Re: Site Plan I
Phase I Permit Application
Town Center Project
400 Boston Post Road
Wayland, MA

**Site Plan I Approval
Submission**

RE: Recommendations on the Phase I Site Plan
Review; Submission 1, May 12, 2008

Wayland MUOD Phase I Site Plan Review

Drawing Title:
Building 1-C Elevations
Drawing Number
SCALE 1/8"=1'-0" **A3.3**

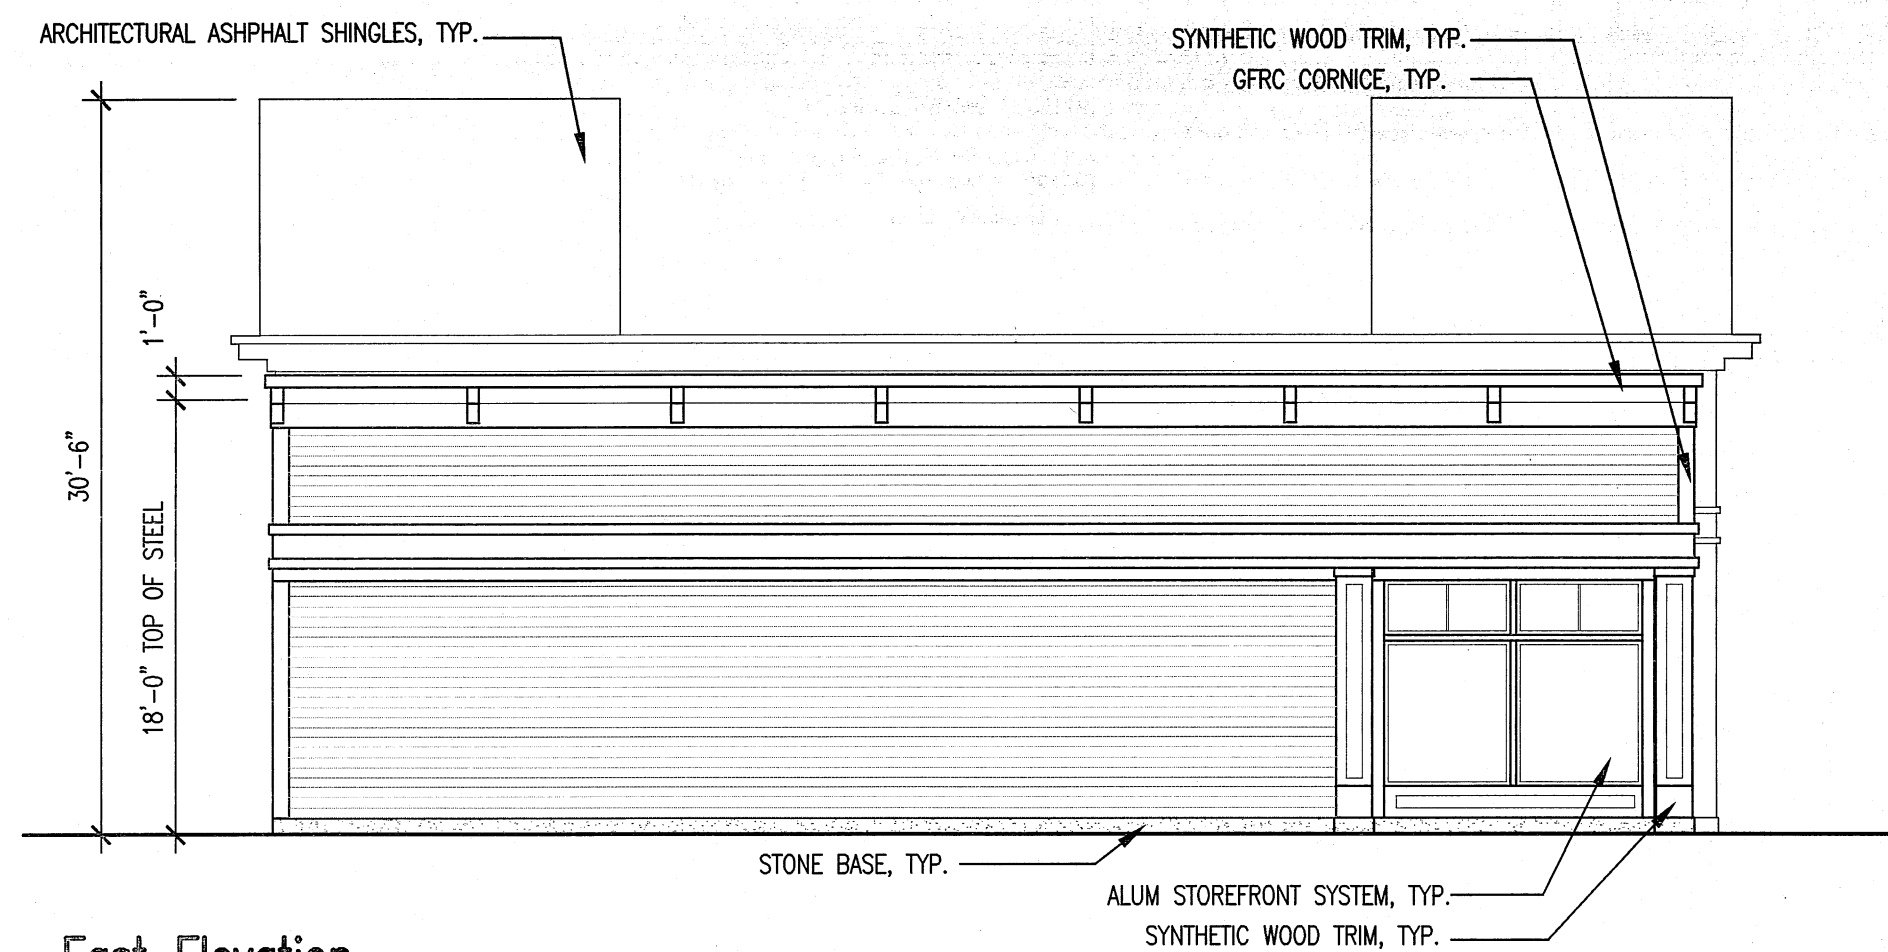
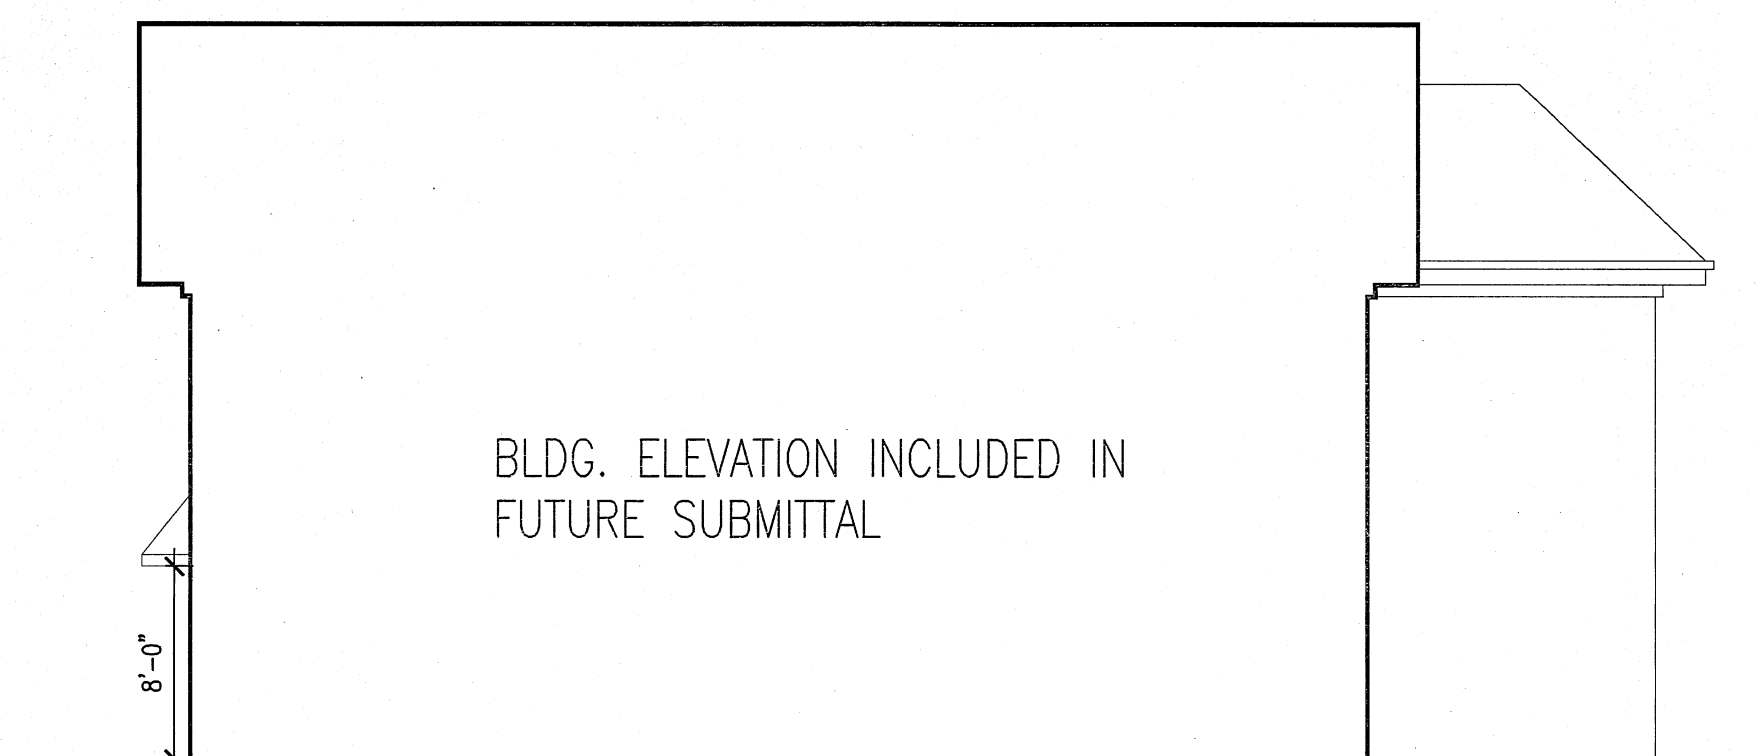
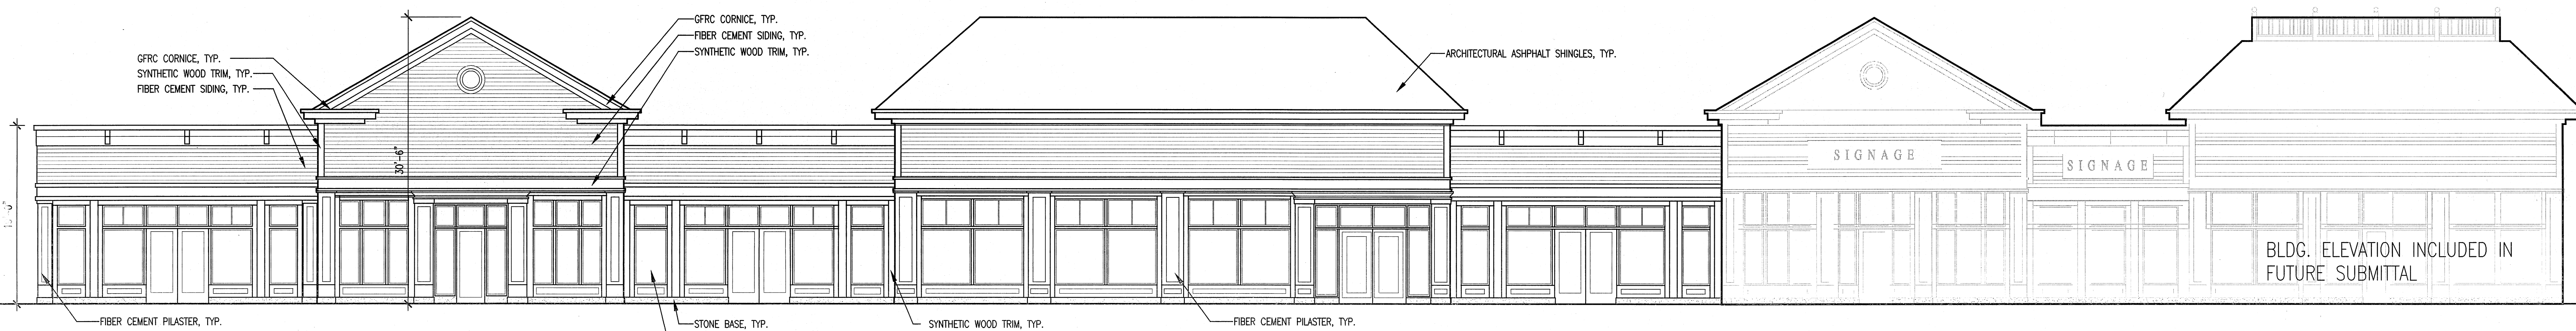
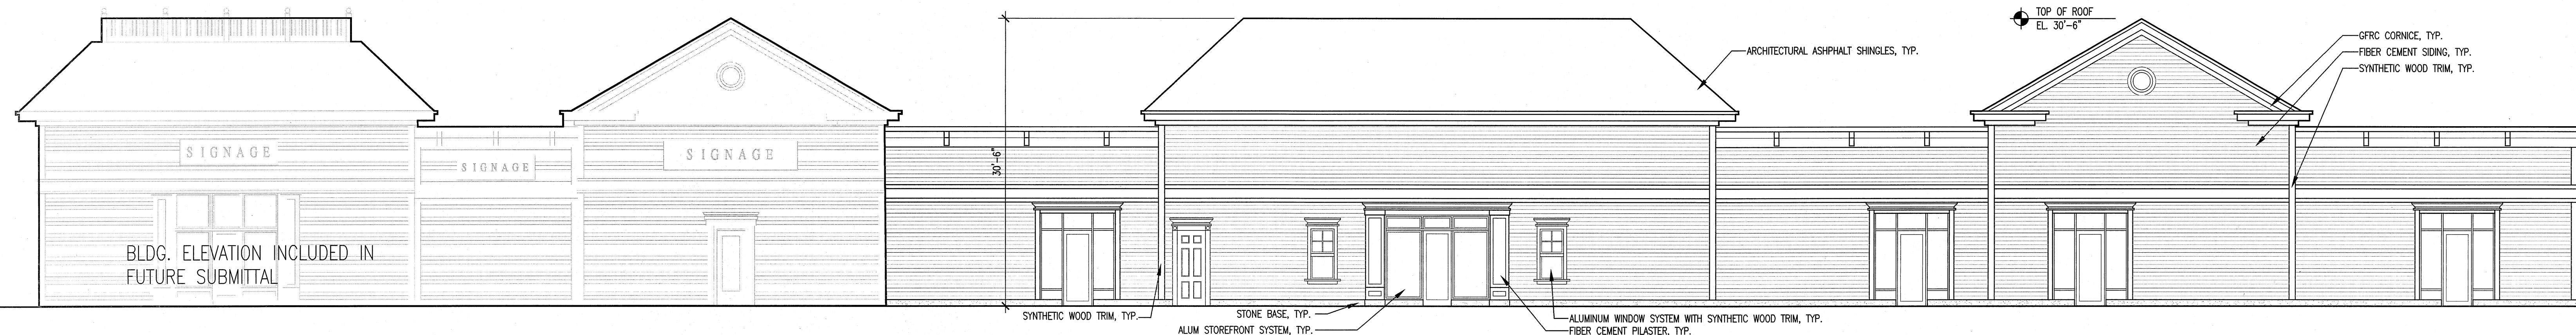
Bldg 1-C	<p>Maximum number and area of window and door openings is found on the North elevation facing the street. East and West elevations include the least number and area of openings.</p> <p>Transoms at the door openings are indicated on the drawing, but materials are not specified.</p> <p>Awnings are added on the North elevation.</p>	The submission does not indicate proposal for daylighting and ventilation.	There is insufficient information in the submission to make findings regarding daylighting and ventilation.

property lines between the buildings. Images of traditional combined and separated rooflines are included below.	
Bldg 1-C	The same analysis of Building 1-C is that of Building 1-B, in that the base is a highly similar design with what appears to be an applied roof above that is not integrated with the base. The same issue of roof and cornice overlaps applies as one of the reasons for this appearance.	It is recommended that the Planning Board consider the design as requiring modifications to be recognized as “authentic, New England regional character.”

Drawing Number
SCALE As Noted **A4.1**

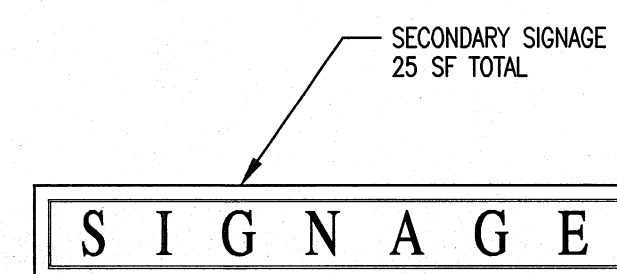
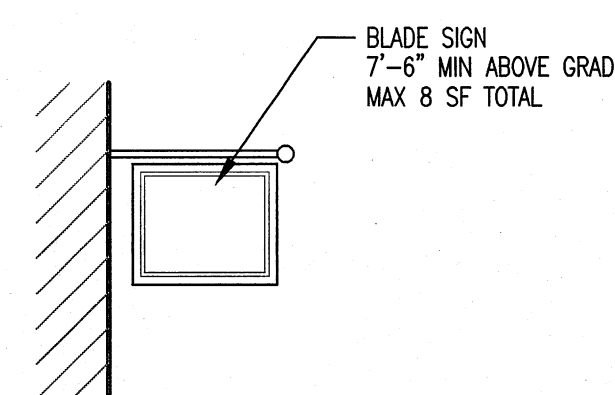
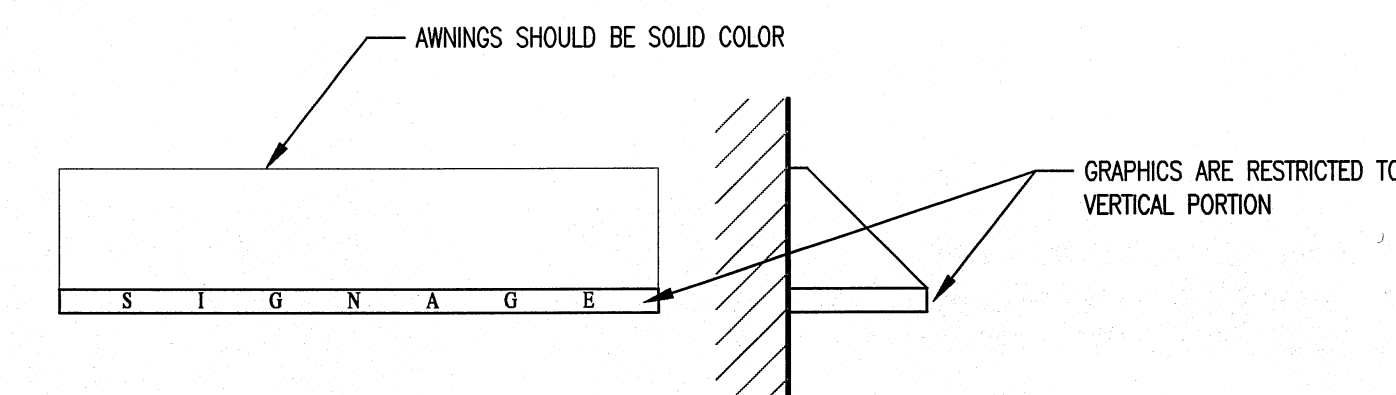
5. Existing and proposed signs.	Applies to submission	Tenant and building signs shown on the submitted plan A4.1 (see table – Building/Tenant Signage).

5. Tenant-Establishment Signs. a.) Wall signs.	Applies to submission	Compliance as noted below.
(i) Wall signs for commercial establishments in the MUP shall comply with the dimensional requirements of §198-2309.4.2 and §198-2309.4.3 of the By-Laws.	Applies to submission	<p>The proposed buildings show single sign, primary wall and secondary wall tenant signs which conform to the dimensional requirements under the Bylaws for Size Category C, D, and E uses.</p> <p>It is recommended that the Planning Board find the proposed tenant signage consistent with this standard.</p>
(ii) The aggregate area for signage for wall signs for each size category of establishment shall be as set forth in Paragraph 1 of the Signage Summary.	Applies to submission	The Size Category E uses have an allowed aggregate of 6,384sf, whereas total aggregate signage proposed is calculated to be 1,108sf. This portion proposed under the submission is equivalent to about 17.3% of the total aggregate allowed signage which is

<p>equivalent to the portion of maximum building area. Consequently, this signage detail could be used consistently throughout the project. This analysis does not include miscellaneous signs.</p> <p>It is recommended that the Planning Board find the proposed tenant signage consistent with this standard.</p>
(iii) Primary and secondary walls for wall signs for purposes of § 198-2309.4.2 shall be designated during the Phase I Site Plan Review Process.	Applies to submission	<p>The primary and secondary walls are defined by the location of sign types on sheet A4.1 of the submission (see table – Building/Tenant Signage).</p> <p>It is recommended that the Planning Board find the walls designated as per the sign type.</p>
<p>b.) Blade, awning and identification signs.</p> <p>(i) The numbers and areas of blade, awning and identification signs for each size category of establishment shall be as set forth in Paragraph 2 of the Signage Summary.</p>	Applies to submission	<p>The blade and awning signs are indicated on the sheet A4.1. The identification signs (ID/Hours/Misc.) are not indicated on the plans.</p> <p>The recommendation is that the decision includes a finding that the Size Category Uses shown are allowed an additional 5sf of ID signs in addition to those signs shown in the Phase I Site Plan Review submission. Locations of these signs could be clarified for the building permit review with specific criteria.</p>
